**City of Portland, Maine – Building or Use Permit Application** 389 Congress Street, 04101, Tel: (207) 874-8703, FAX: 874-8716

RE: 29 Oregon Street

Your application to construct a new sunroom 8 x 12 on an existing deck has been reviewed and a permit is herewith issued subject to the following requirements. This permit does not excuse the applicant from meeting applicable State and Federal laws.

REASON FOR PERMIT: To construct sun room on existing deck

<b>PLOT PLAN MADE FOR PAUL LEDDY - LEDDY BUILDERS</b> 29 OREGON AVENUE PORTLAND, MAINE		
SCALE: 1" = 30'±	APPROVED BY	DRAWN BY
DATE: 8-19-97	BY: DANIEL J. DALFONSO LAND SURVEYOR 119 SCAMMAN ST. SO. PORTLAND, ME.	
PHONE: 799-5931		DRAWING NUMBER 499

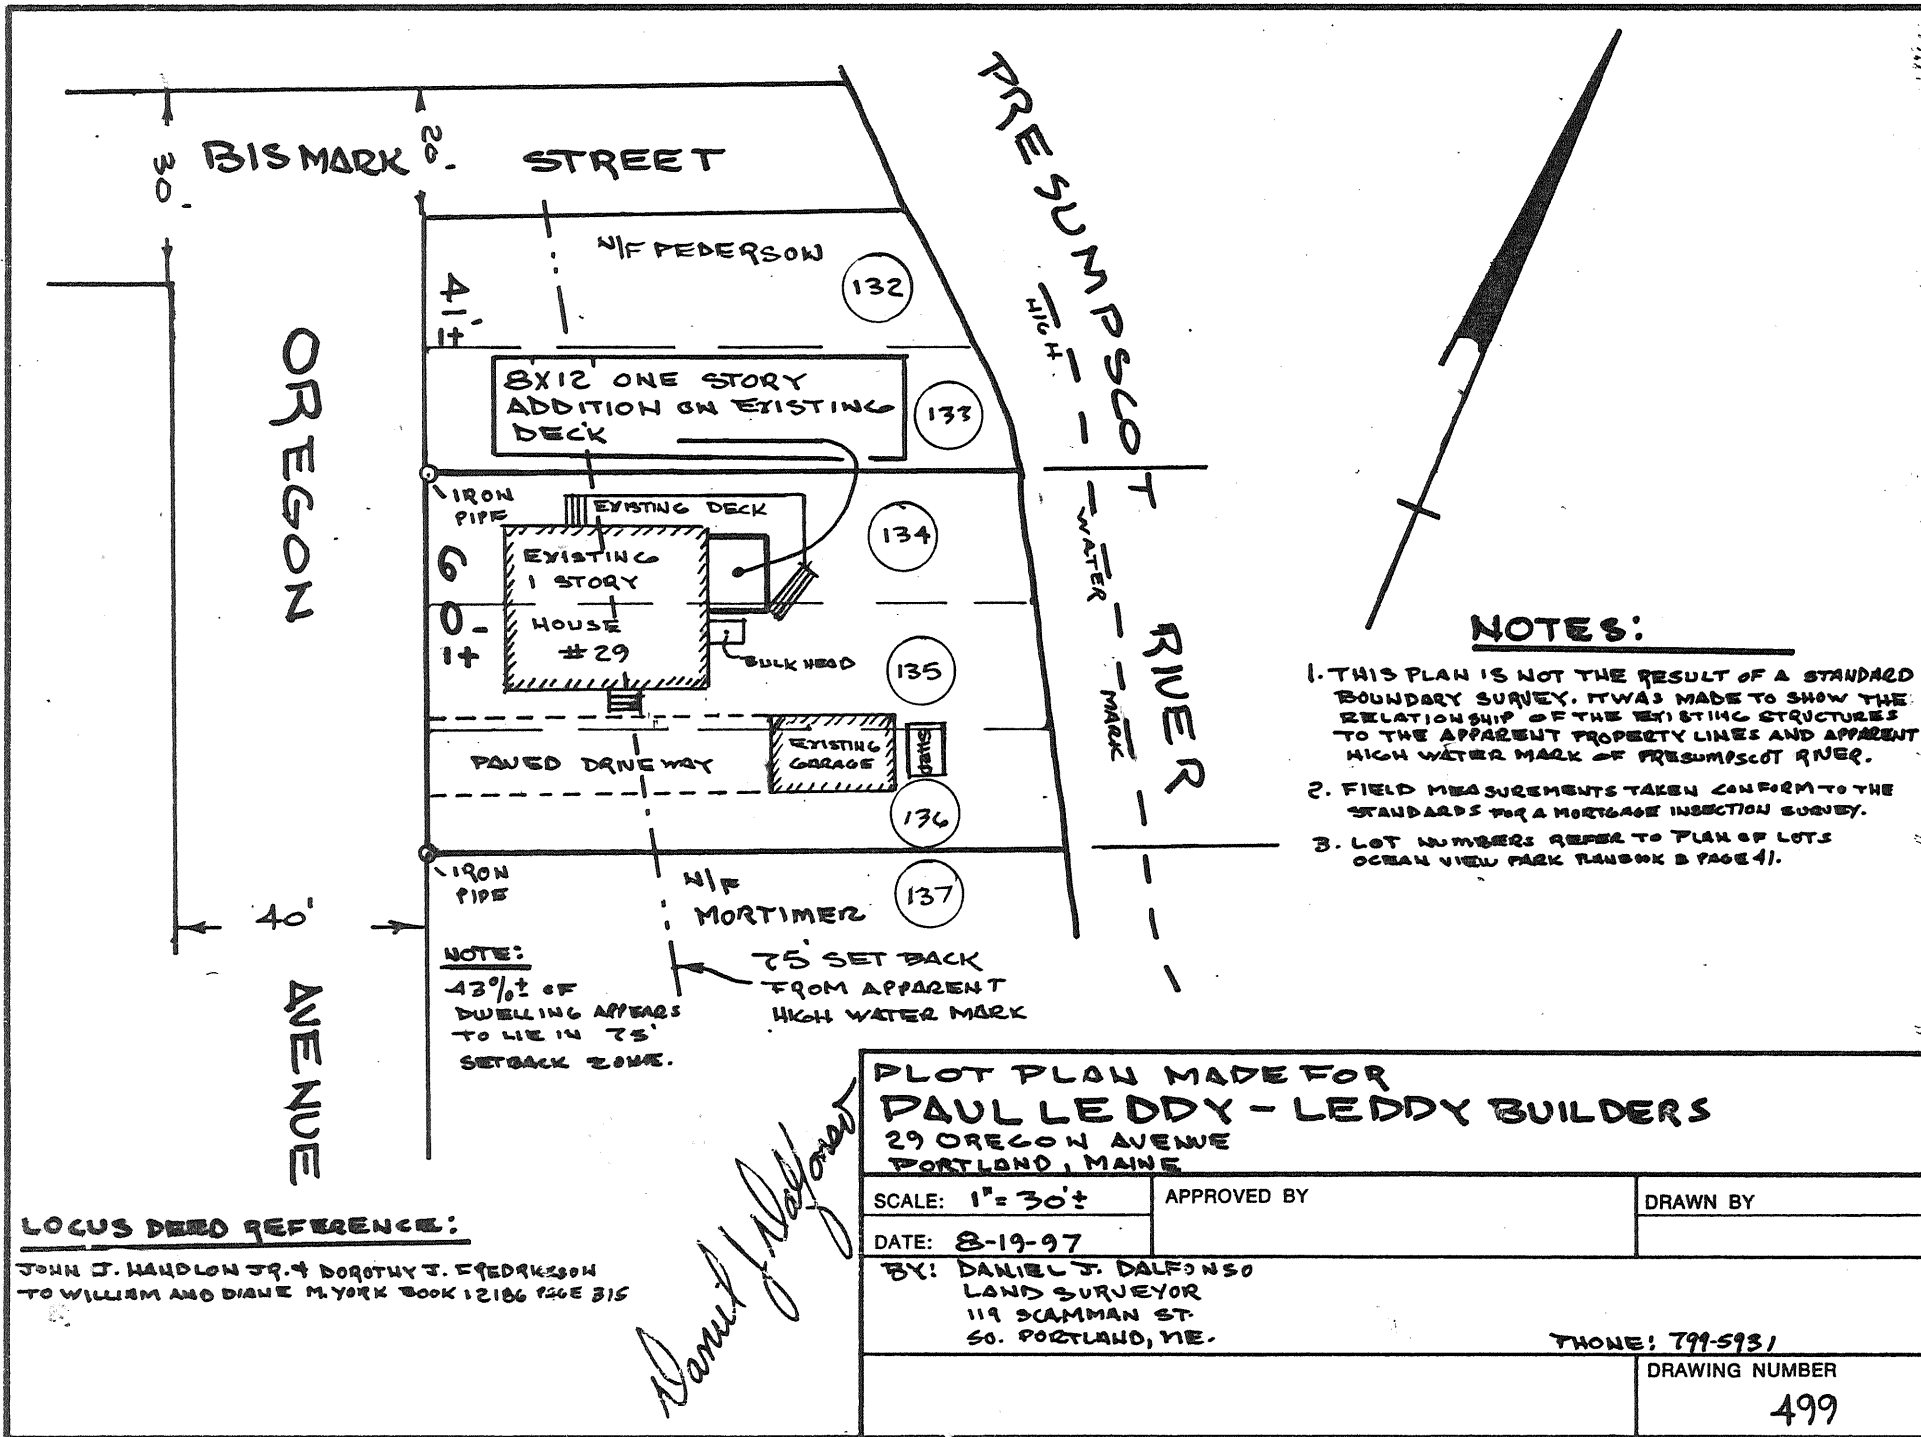
Exit Squares 448 # of present bldg is in 75' setback

Existing cubic footage: 3584 cu. ft. - 1st floor  
1456 cu. ft. - 2nd floor

5040 TOTAL cu. ft. in existing house within the 75' setback

5,710 #  $5040 \times 30\% = 1512$  allowable increase

New Addition - NO NEW square footage - is on existing deck

$8 \times 12 = 96^2 \times 8' = 768$  cubic footage - 1st floor

1056 cubic footage total

yes within 75' setback

This property is situated within the Shoreland Zone with a portion of the structure within 75 feet of the high water mark. With this proposed structure most of the one time 30% cubical volume increase has been met. Any future changes shall only be allowed based on what has been allowed within this permit.
